Subject: Response to Department of Toxic Substances Control Comments Regarding the November 30, 2011 "Soil Gas Sampling Results, Campus Bay and University of California Richmond Field Station Property Boundary, Richmond, California"

## **Zeneca's Responses to DTSC's January 19, 2012 Comment Letter**

Subject: Revised Soil Gas Sampling Results, Campus Bay and University of California Richmond Field Station Property Boundary, Richmond, California.

**Table 1**  
**Soil-Gas Analytical Results**  
**Campus Bay and UC Richmond Field Station Property Boundary, Richmond, California**

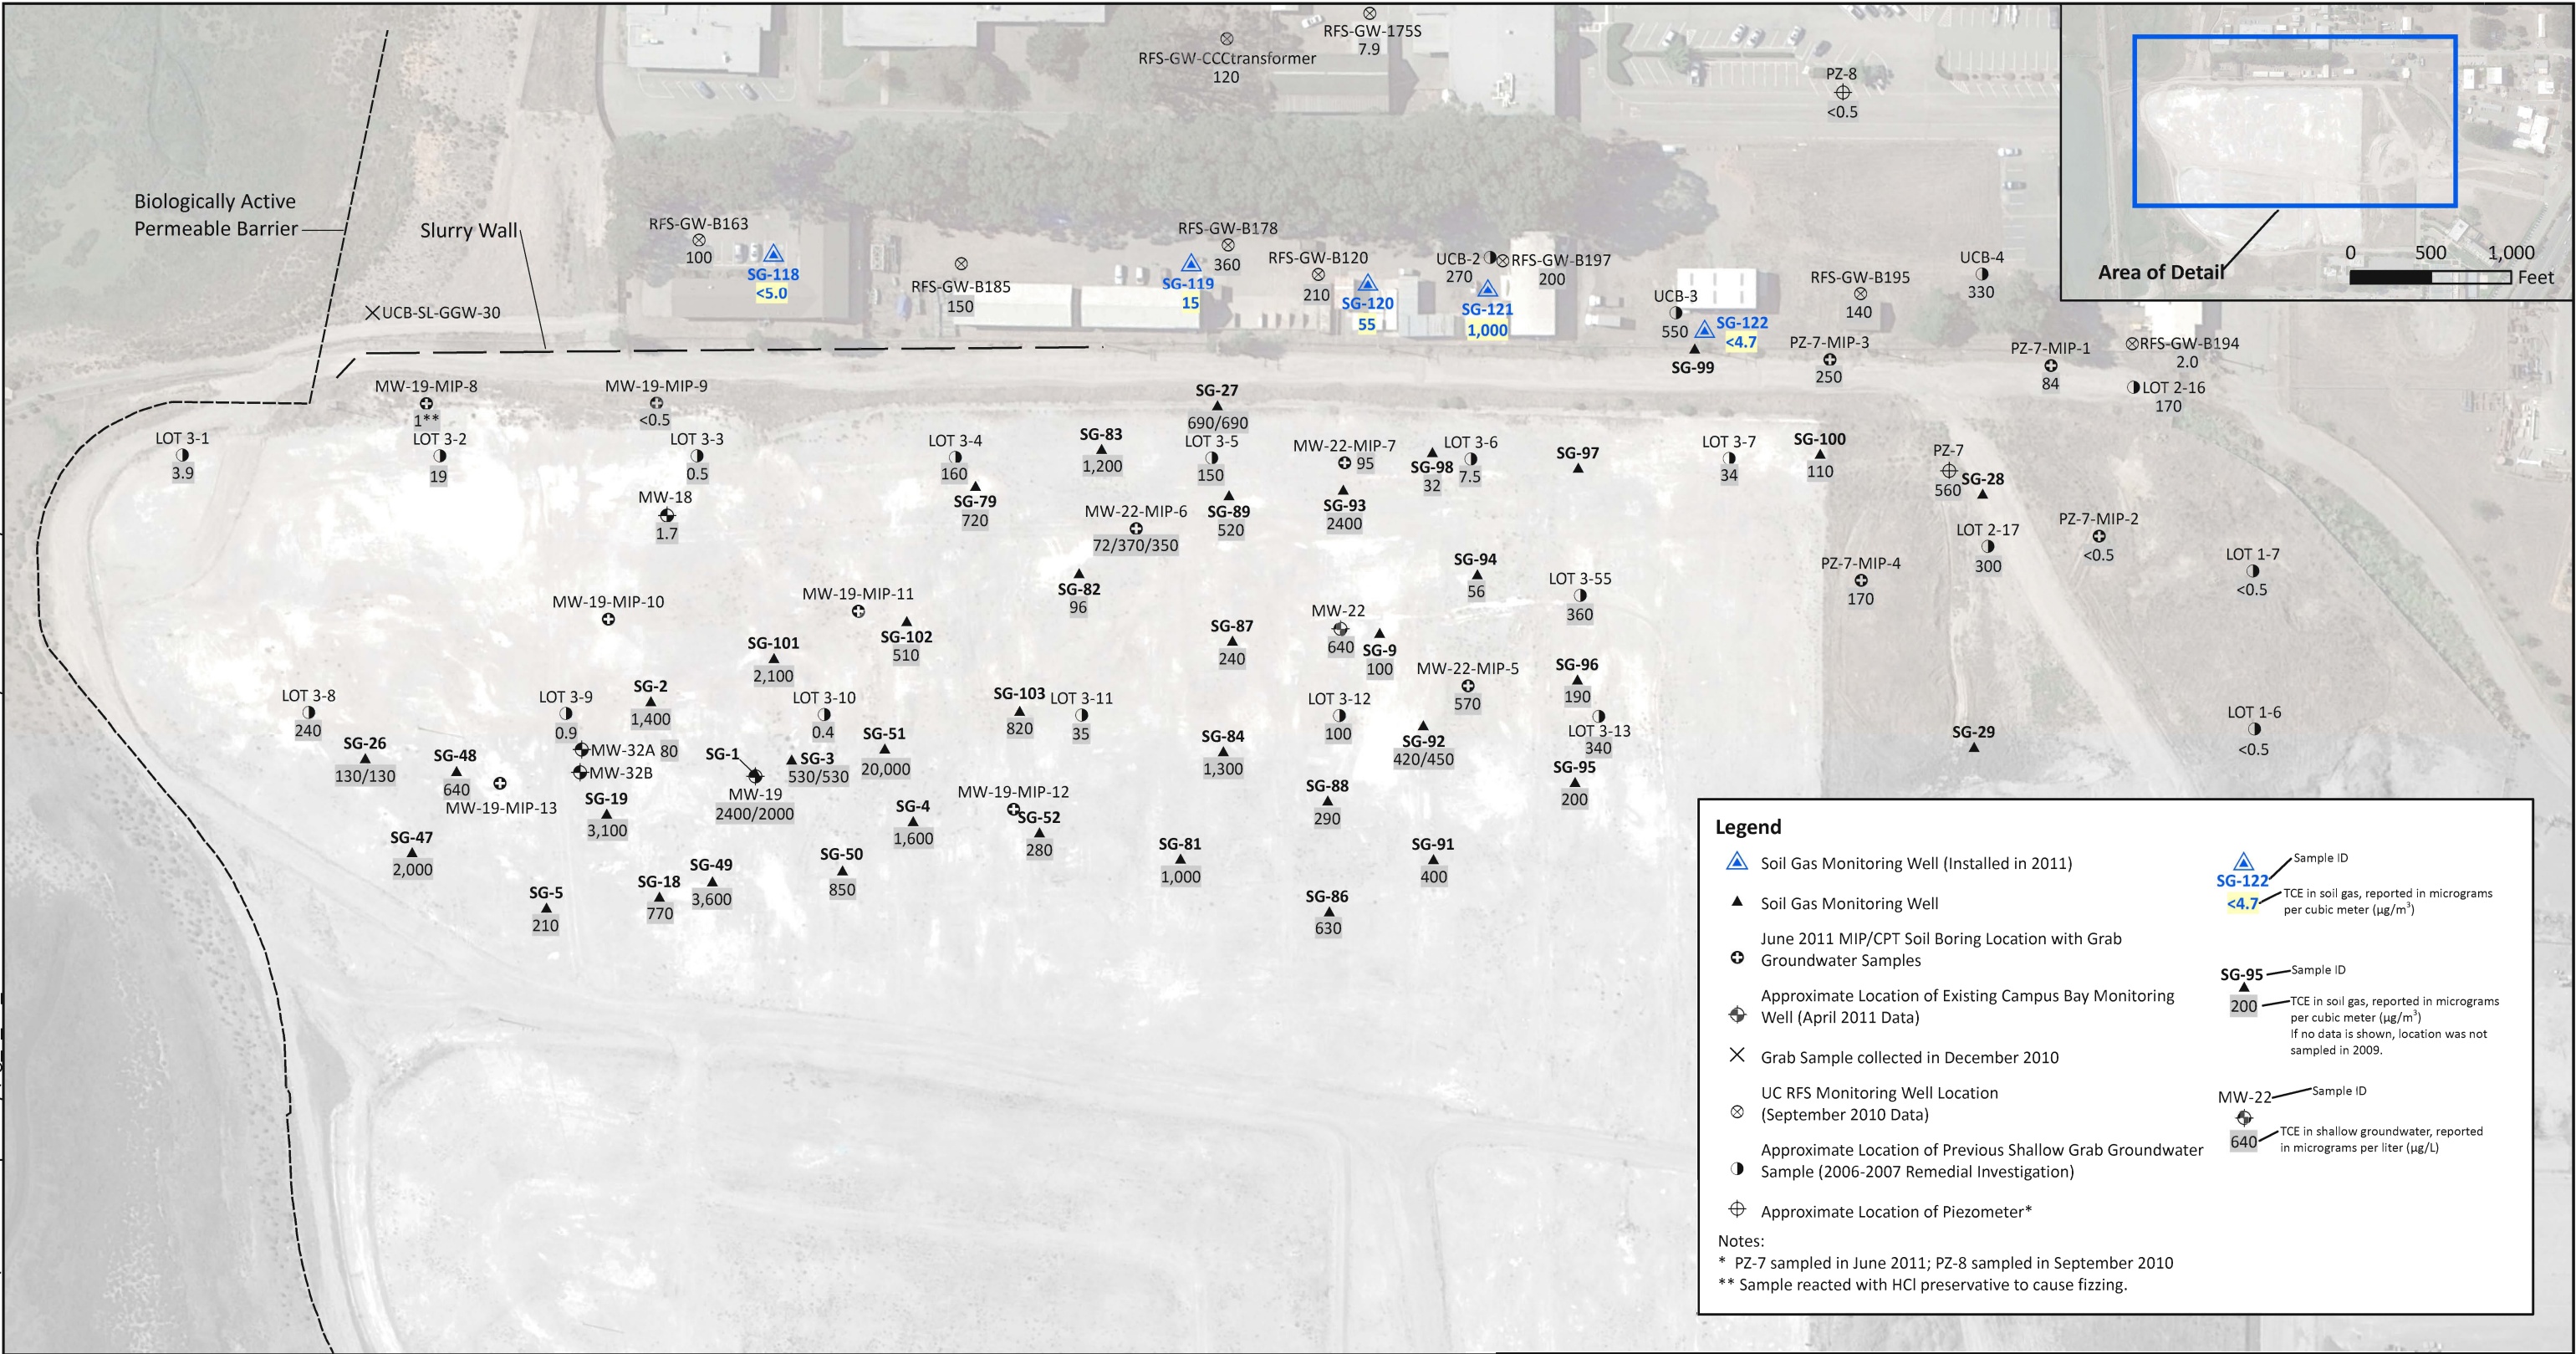
*"The U.S. Environmental Protection Agency (U.S. EPA) Integrated Risk Information System (IRIS) revised the toxicity criteria for TCE on September 28, 2011. The screening values identified in Table 1 need to be re-calculated to reflect the updated risk and hazard values based on the updated toxicity criteria for TCE. Based on the revised value, all applicable text should also be revised."*

*"Amend Table 1 by removing the notes that do not apply to the table. Also, two additional columns should be added to the table. One column should provide the depth to groundwater for each soil gas sample location and another providing the depths of the individual vapor probes. While this information is available in the boring logs, this information will assist the reader in understanding the site conditions."*

The Campus Bay site specific goals for trichloroethylene (TCE) were updated in the July 19, 2012 "Revised TCE Risk Evaluation Technical Memorandum" ("the TCE Risk Technical Memorandum") submitted by Terraphase on behalf of Zeneca. The DTSC approved the TCE Risk Technical Memorandum in a letter dated October 4, 2012. In accordance with the TCE Risk Technical Memorandum, the Commercial Industrial Worker (CIW) Site Specific Goal (SSG) for TCE in soil gas was reduced from

In response to this comment, Terraphase has amended the notes provided in Table 1 as requested. Table 1 has also been amended to include the depth interval of the sand pack of each soil vapor probe. Please note that the soil borings for the soil gas wells were not advanced to groundwater. As discussed in the Soil Gas Report, the following information was used to determine the appropriate depth of each soil vapor probe:
